NRC Periodic Compliance Monitoring Report for U.S. Department of Energy Non-High-Level Waste Disposal Actions

Annual Report for Calendar Year 2010

Figure 2: INTEC TFF Monitoring-Well Network (from DOE-Idaho, 2010)

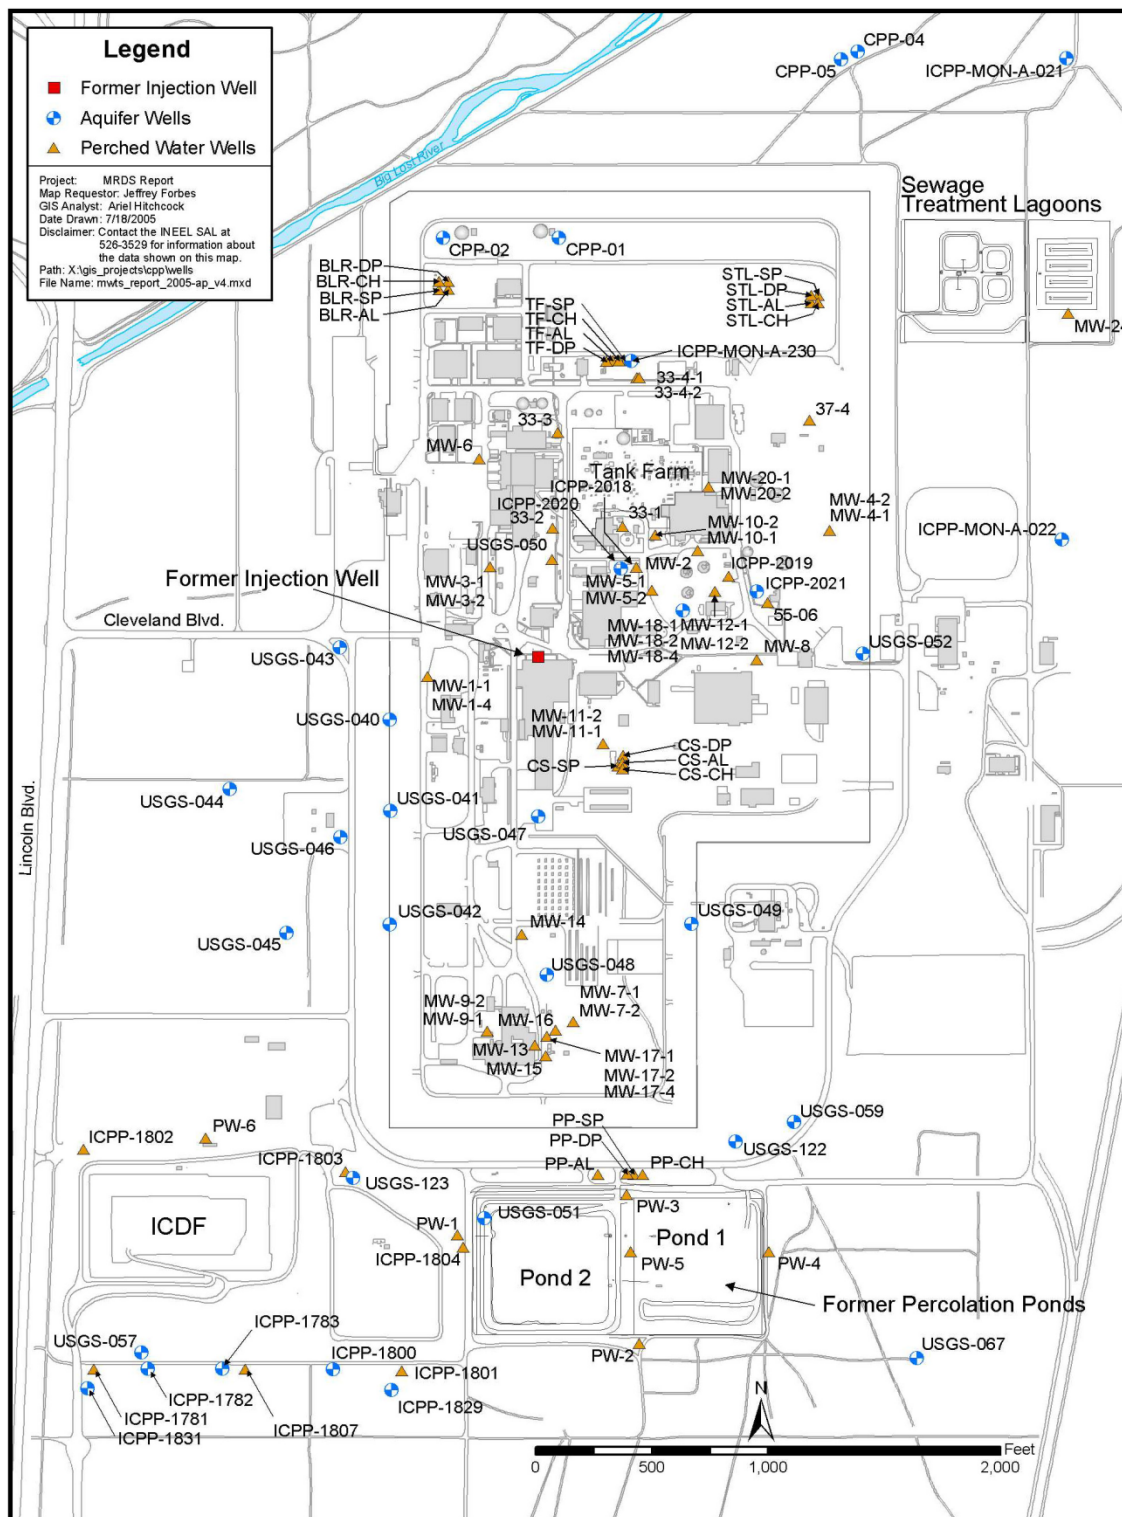
Consistent with previous data, the highest Tc-99 concentrations were associated with monitoring well ICPP-MON-A-230 (2,220 pCi/L) located near the INTEC Tank Farm and the second-highest Tc-99 concentrations were measured at aquifer well ICPP-2021 (1,240 pCi/L), located southeast of the Tank Farm (see Figure 2 above). These two wells were the only wells to exceed the Tc-99 MCL of 900 pCi/L. ICPP-2020 was the only well that showed a significantly higher Tc-99 level (382 pCi/L) than was reported in previous years (e.g., 215 pCi/L in FY 2007). All other wells showed stable or declining trends.

Consistent with previous data, very high Sr-90 levels (>10,000 pCi/L) were observed in the northern shallow perched water across INTEC. The highest Sr-90 concentrations were observed in wells southeast of the Tank Farm. The maximum Sr-90 concentration detected was 130,000 pCi/L at monitoring well ICPP-2018 (see Figure 2). At most well locations, Sr-90 concentrations were similar to those observed during the previous year, but are approximately half those reported in the same wells during the mid-1990s due to decay and transport. Gross beta activity was detected at nearly all perched water sampling locations with the highest gross beta level occurring at well ICPP-2018 (311,000 pCi/L) consistent with the Sr-90 data.

Recommendation 2010-1: NRC staff recommended that the PA reflect the results of simulations performed and additional documentation generated during the NDAA consultation process to answer NRC staff inquiry regarding the cause and performance impact of the significant lateral spread of the contaminant plume emanating from the TFF to the south (e.g., caused by pressure gradient from BLR and resulted in up to a factor of 10,000 decrease in contaminant concentrations emanating from the tank farm facility for relatively mobile [non-sorbing] constituents such as Tc-99 and I-129).

Figure 1: Disposal Cell Depiction (not to scale)

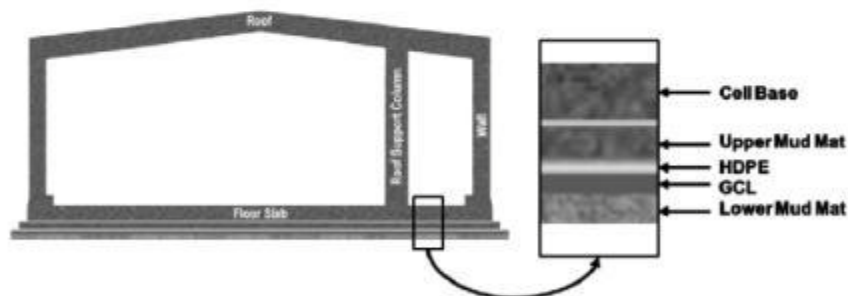
around the base of the cell (Figure 1). Due to the presence of damp spots on cell 2B, the hydrostatic test of cell 2B was postponed and investigations were performed to determine the source of the spots.

The NRC staff visited the site to observe the progress of examining the root cause of the damp spots. At the time of the observation, the vendor CROM was in the process of removing the outer layer of shotcrete on the outside base of the cell at the points exhibiting damp spots. In addition, spots noticed at a lower point (between the upper mud mat and the cell floor, note Figure 1) provided sufficient evidence for portions of the upper mud mat to be removed enough to see the circumference of the cell floor under the base of the cell. SRR staff walked NRC staff around the circumference of the cell and requested multiple photos be taken at various points during this portion of the tour (available at ADAMS accession number ML101460045). In all, 33 damp spots were identified at various spaces around the circumference of the cell. These spots were slightly damp to the touch, but were mostly evident by sight. NRC staff asked various questions pertaining to the timing of the damp spots and any correlations the location of the spots had with construction materials, components, etc. that might have been noticed by SRR or CROM staff. A question of note asked by NRC staff was what effect the presence of damp spots will have on the hydro-test procedures, specifically, will any chemical or visual tracers be used in future hydro-tests (e.g. cell 2A hydro-test). SRR staff responded to the question by saying that insertion of a tracer will be considered for the hydro-test of cell 2A. Damp spots are of interest to the NRC staff because their unexpected presence and the corrective actions to repair them could each have some effect on assumptions made in the performance assessment pertaining to vault performance.

A red dye tracer was then added to the water to distinguish between water inside the cell and water from the surrounding environment, outside the cell.

The NRC staff will continue to monitor actions being taken to investigate the cause of the spots.
